DRAWING NO. D206-667-143	TITLE CROSSTUBE ASS'Y (206L HIGH FWD)	REV. C	<b>DART AEROSPACE LTD ENGINEERING ORDER</b>		D.E.O. NO. D206-667-143-C-1	SHEET NO. SHEET 1 OF 1	SCALE NTS
DRAWN <i>q</i>	CHECKED <i>ASS</i>	MFG. APPR. <i>[Signature]</i>	APPROVED <i>[Signature]</i>		DE APPR. <i>[Signature]</i>		
DATE 11.07.15	DATE 11.07.20	DATE 11.07.21	DATE 11/07/21		DATE 11.07.21

REPLACE MAGNOBOND WITH PROSEAL.

DRAWING NO. D206-667-143		TITLE CROSSTUBE ASS'Y (206L HIGH FWD)		REV. C		DART AEROSPACE LTD ENGINEERING ORDER		D.E.O. NO. D206-667-143-C-2		SHEET NO. SHEET 1 OF 1		SCALE NTS	
DRAWN AJS		CHECKED		MFG. APPR. <i>E</i>		APPROVED <i>AP</i>		DE APPR. <i>#</i>					
DATE 12.08.02		DATE 12.08.02		DATE 12.08.02		DATE 12.08.02		DATE 12-08-02

ADD ELECTRICAL GROUNDING STRAP

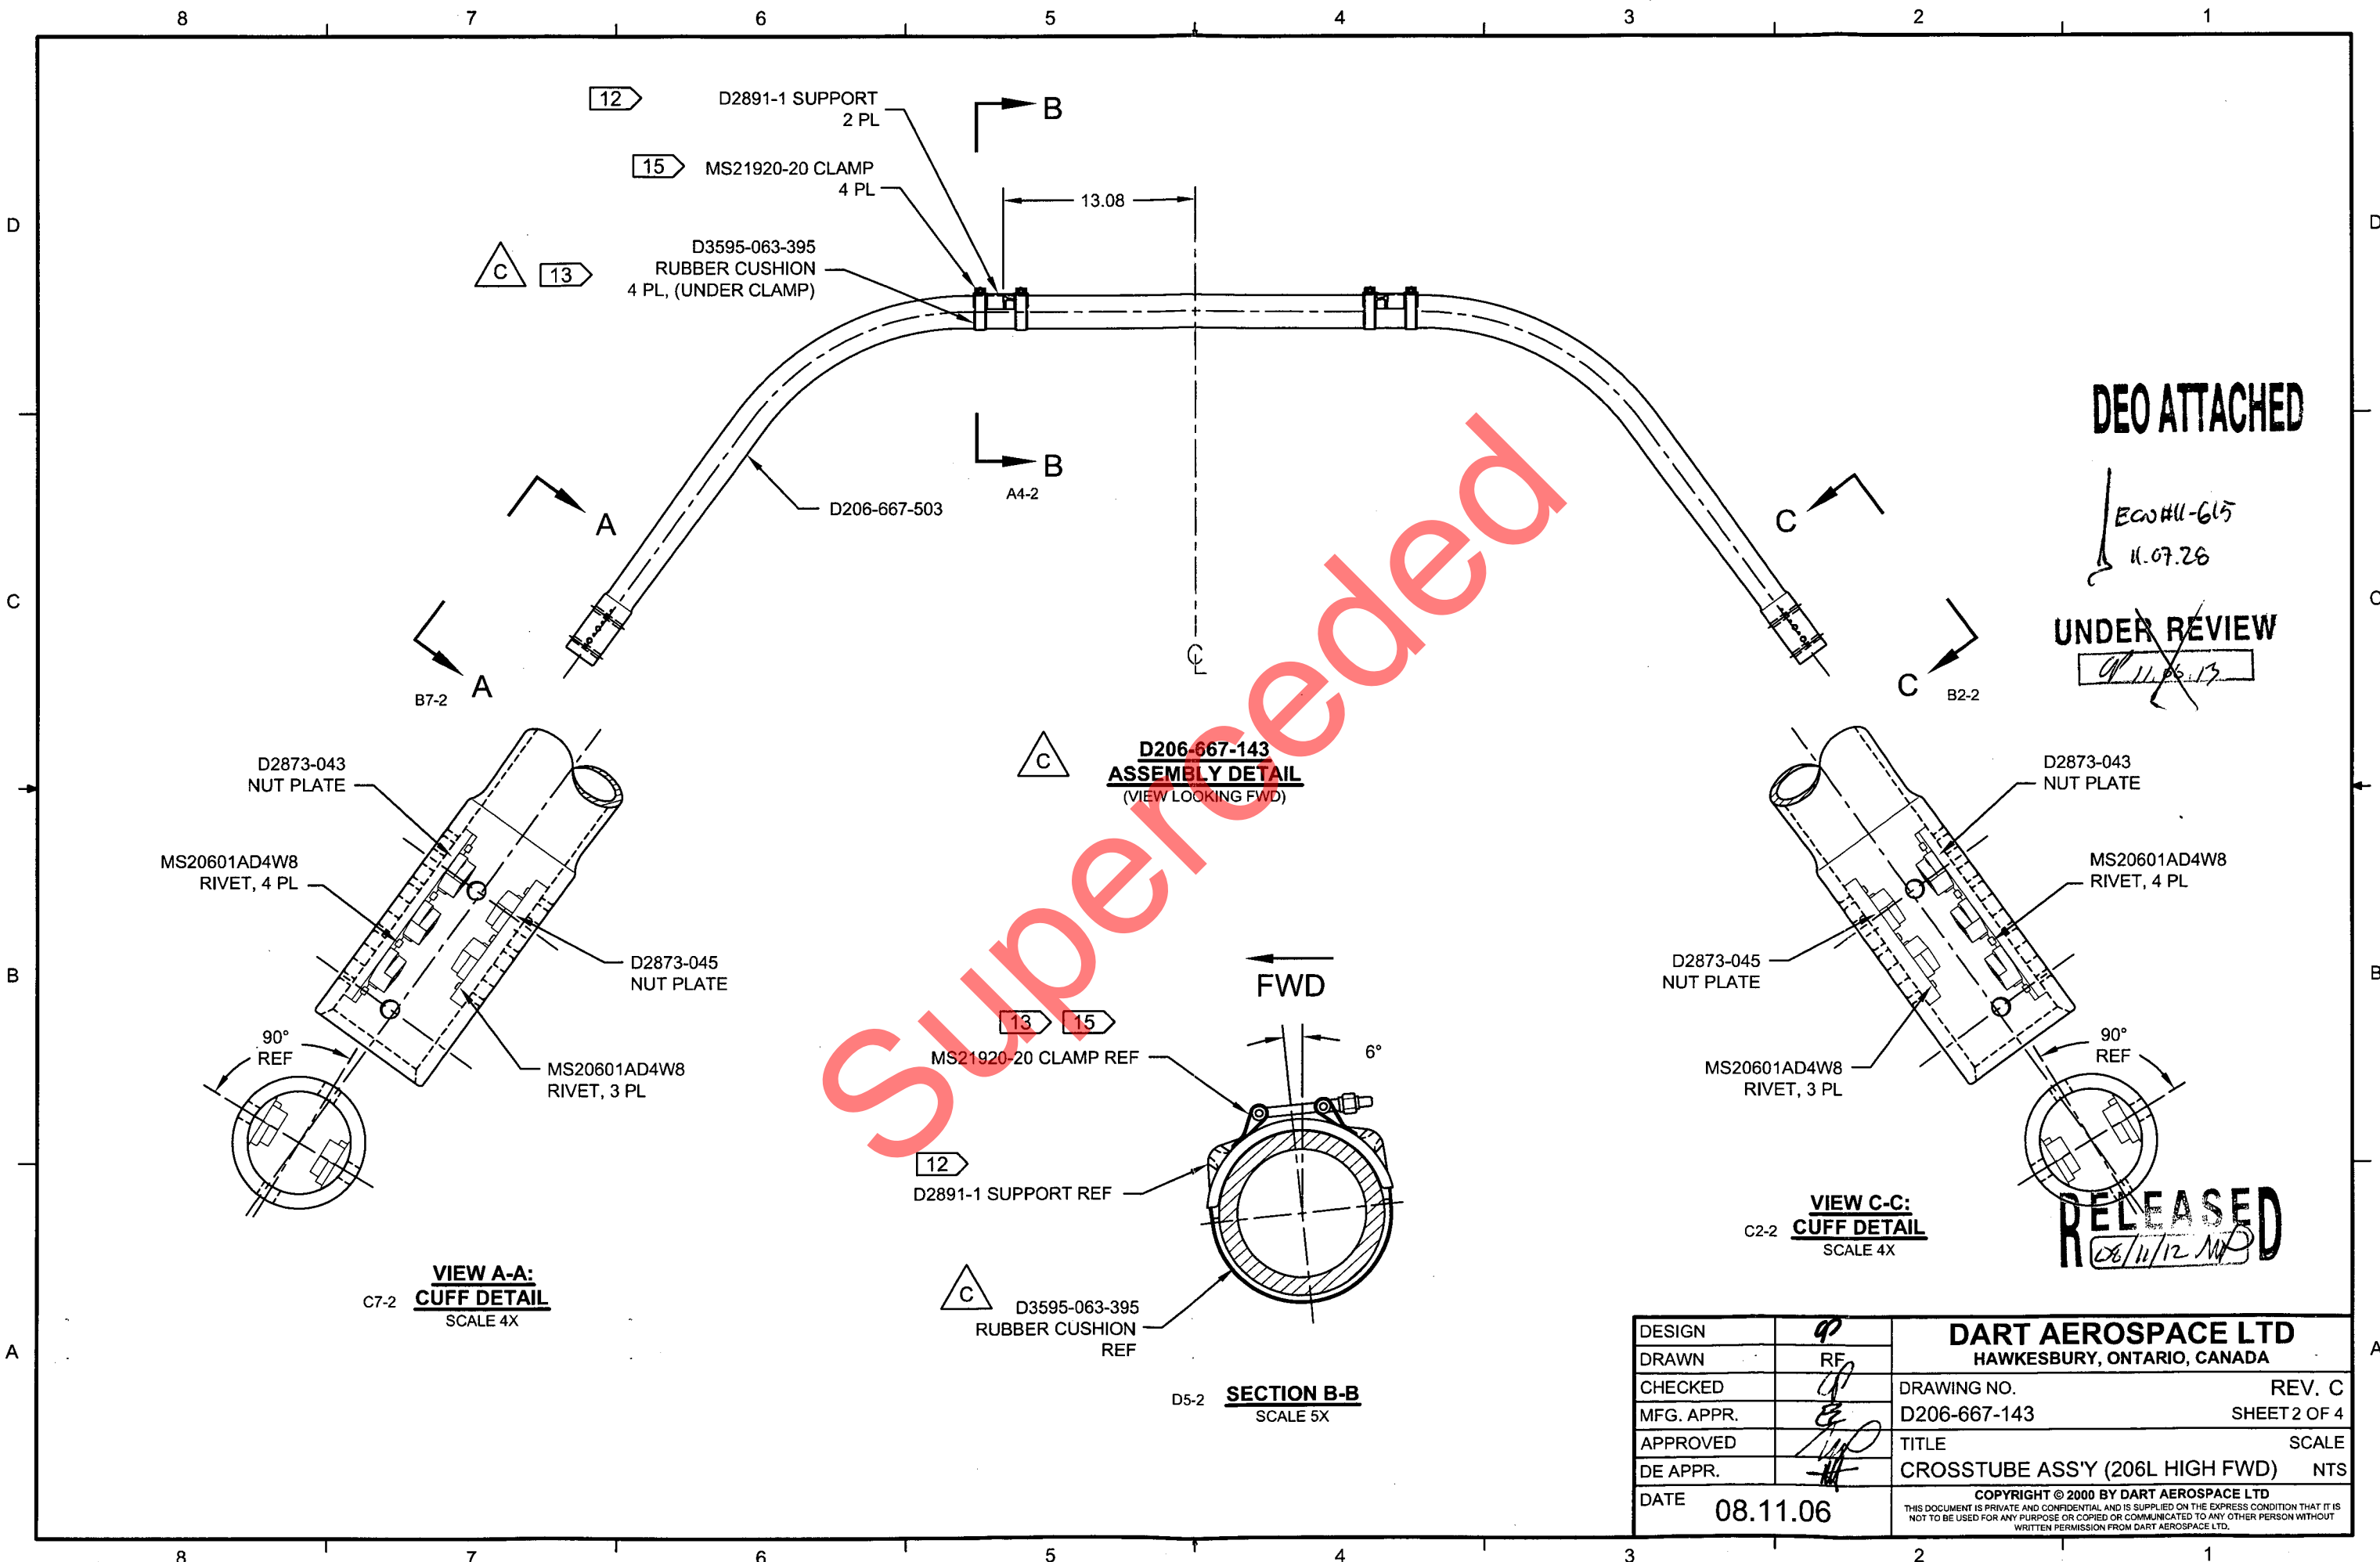
NOTE 12 & 15, SHEET 1 IS AMENDED AS FOLLOWS:

Item	Qty -143	Part Number	Description
9	A/R	PROSEAL 890 B-2	SEALANT, AMS-S-8802 CLASS B-2

- 12) TO INSTALL D2891-1 SUPPORT: ABRASE MATING SURFACE OF SUPPORT AND CROSSTUBE WITH 180-GRIT SANDPAPER AND REMOVE RESIDUE WITH MEK (OR EQUIVALENT). APPLY A 0.04" TO 0.07" THICK LAYER OF PROSEAL 890 CLASS B-2 (OR AMS-S-8802 CLASS B-2) SEALANT TO MATING SURFACE OF SUPPORT.
- 15) TORQUE CLAMPS 80 TO 100 IN-LB. ENSURE AT LEAST 1.5 THREADS SHOWING IN SAFETY AND THAT NUT HAS NOT BOTTOMED-OUT AFTER TORQUING. PRIOR TO PACKAGING, RE-CHECK TORQUE ON CLAMPS AFTER PROSEAL 890 SEALANT HAS CURED FOR 72 HOURS.
